AMERICAN POWER CONVERSION

DESCRIPTION				SHEET
SB208 CIRCUIT BOARD SCHEMATIC				A
PRODUCT: 250/400/600 INT'L BACK-UPS		APCC PART #: 0S-208		
DATE: 3/22/91	BY: ESM	SCALE	DWG: E208-10	REV: 10

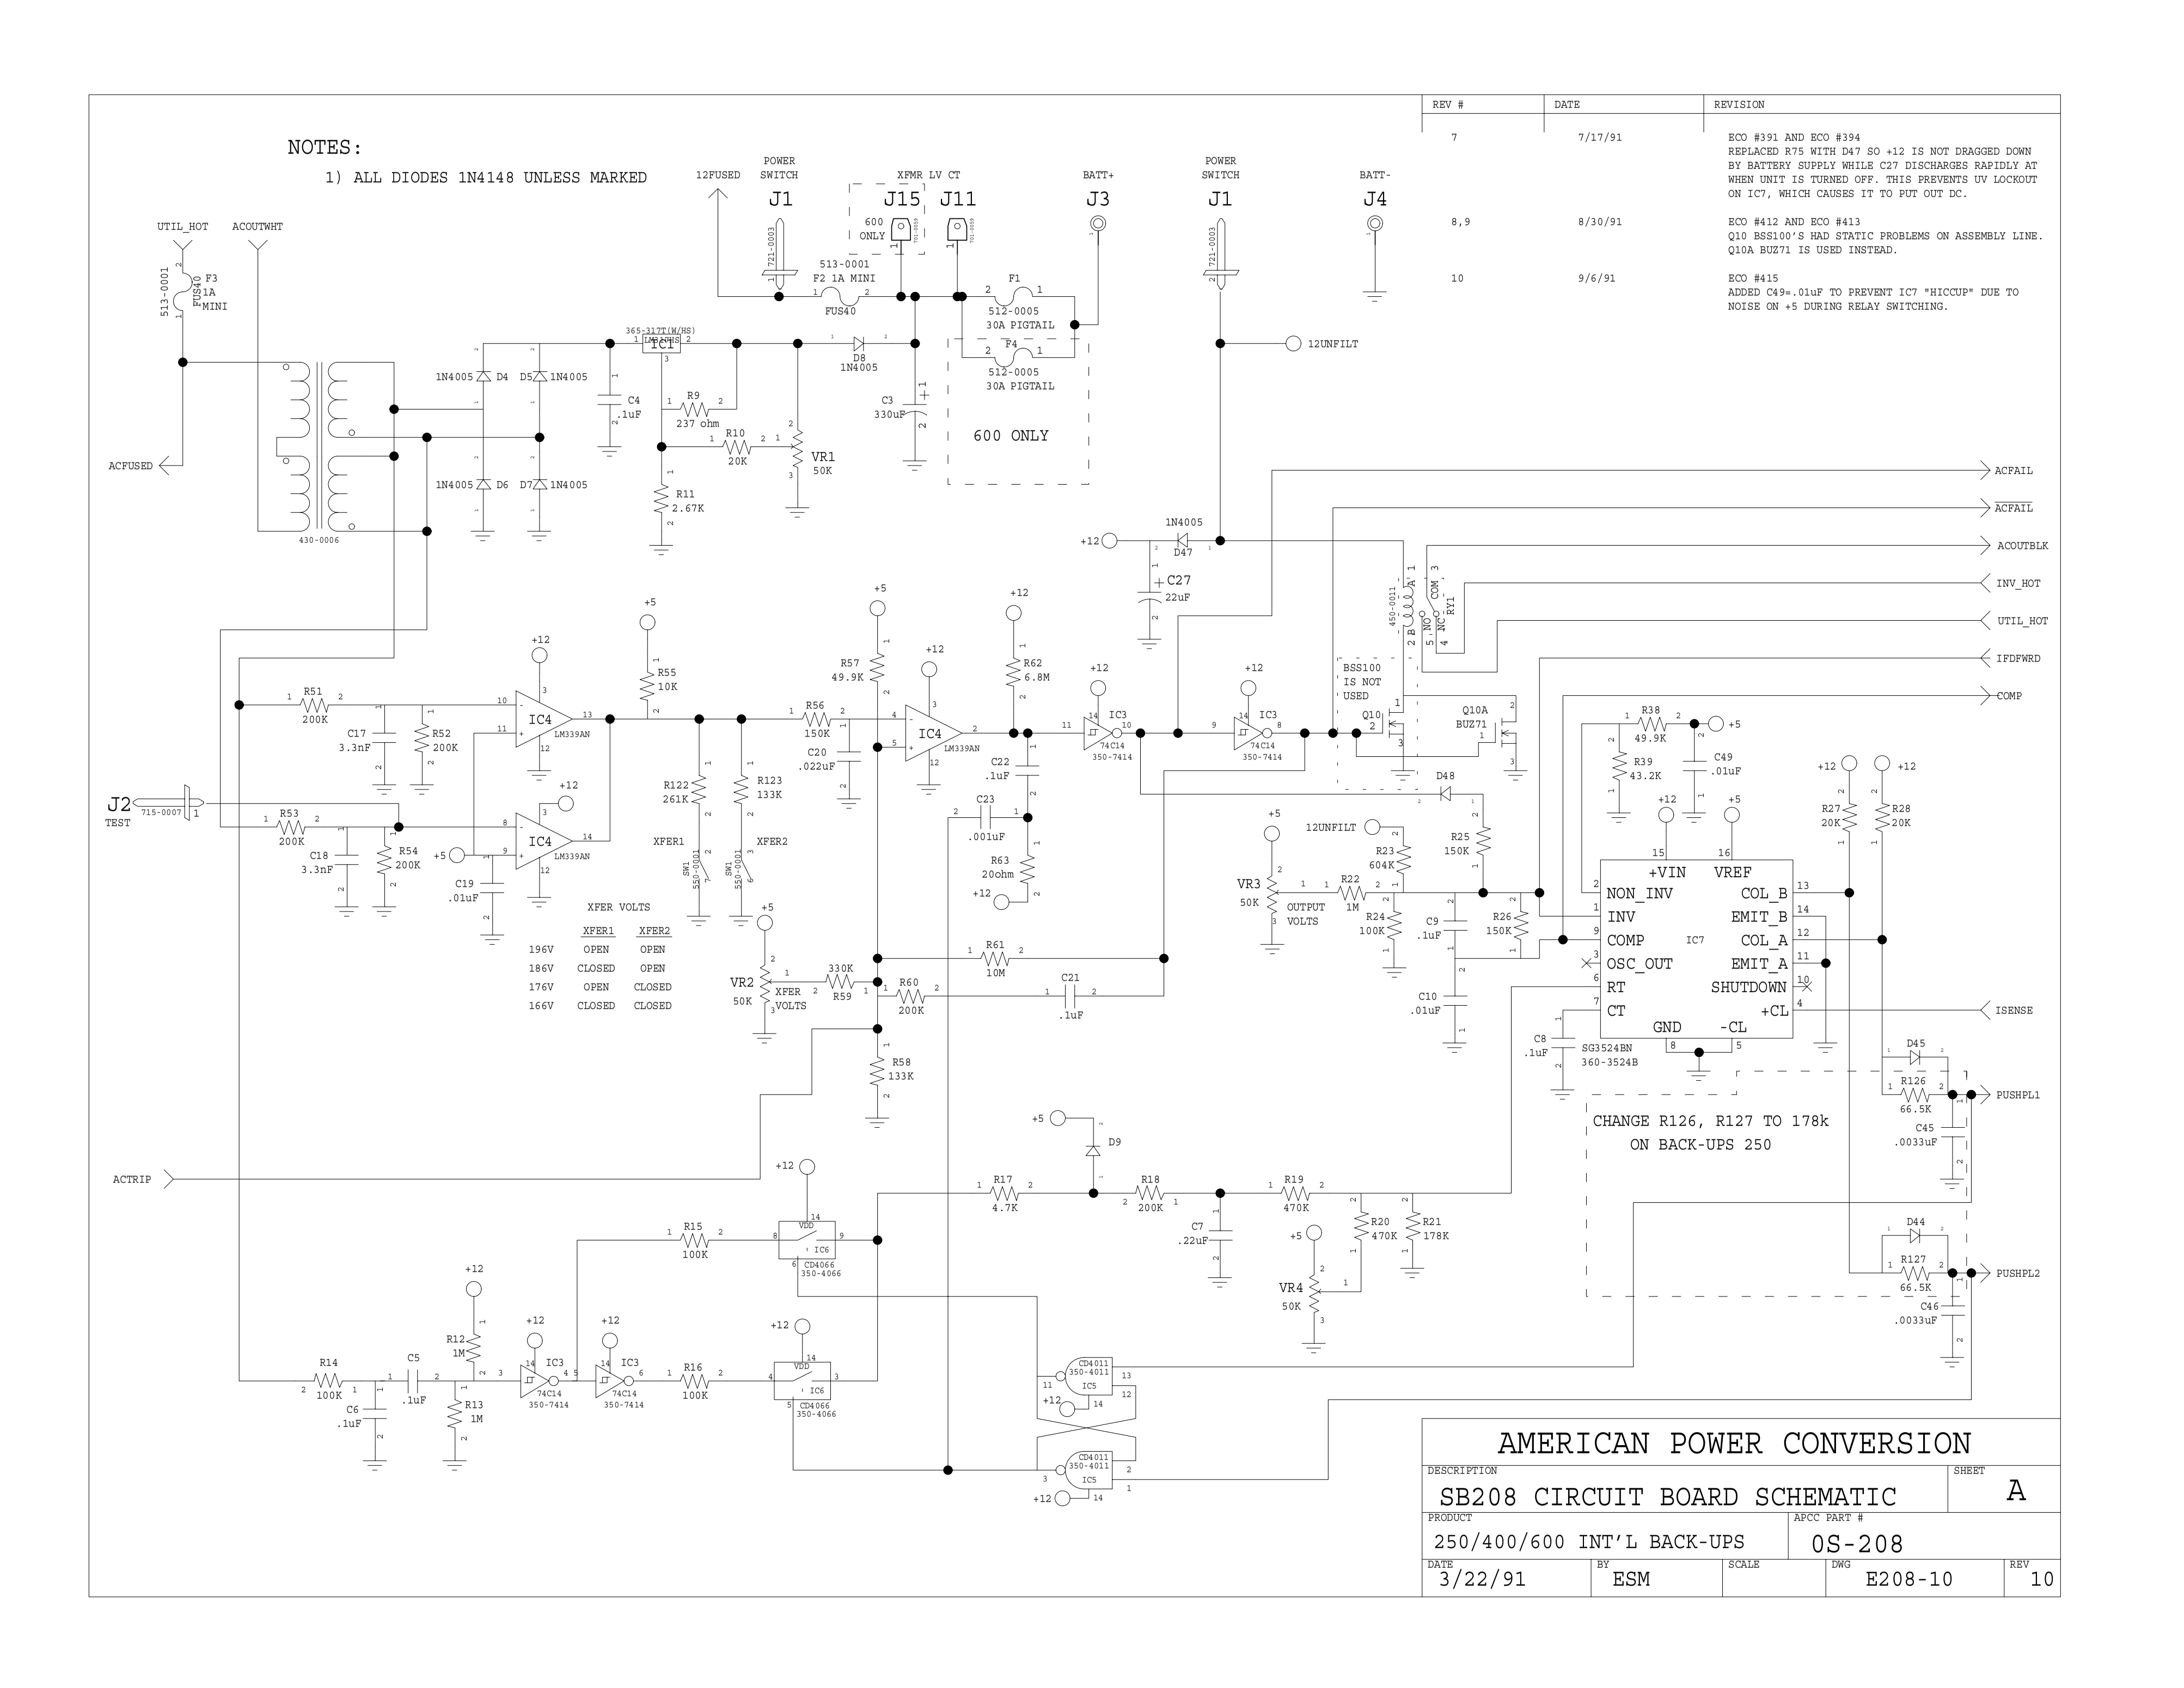
REV #	DATE	REVISION
7	7/17/91	ECO #391 AND ECO #394 REPLACED R75 WITH D47 SO +12 IS NOT DRAGGED DOWN BY BATTERY SUPPLY WHILE C27 DISCHARGES RAPIDLY AT WHEN UNIT IS TURNED OFF. THIS PREVENTS UV LOCKOUT ON IC7, WHICH CAUSES IT TO PUT OUT DC.
8,9	8/30/91	ECO #412 AND ECO #413 Q10 BSS100'S HAD STATIC PROBLEMS ON ASSEMBLY LINE. Q10A BUZ71 IS USED INSTEAD.
10	9/6/91	ECO #415 ADDED C49=.01uF TO PREVENT IC7 "HICCUP" DUE TO NOISE ON +5 DURING RELAY SWITCHING.
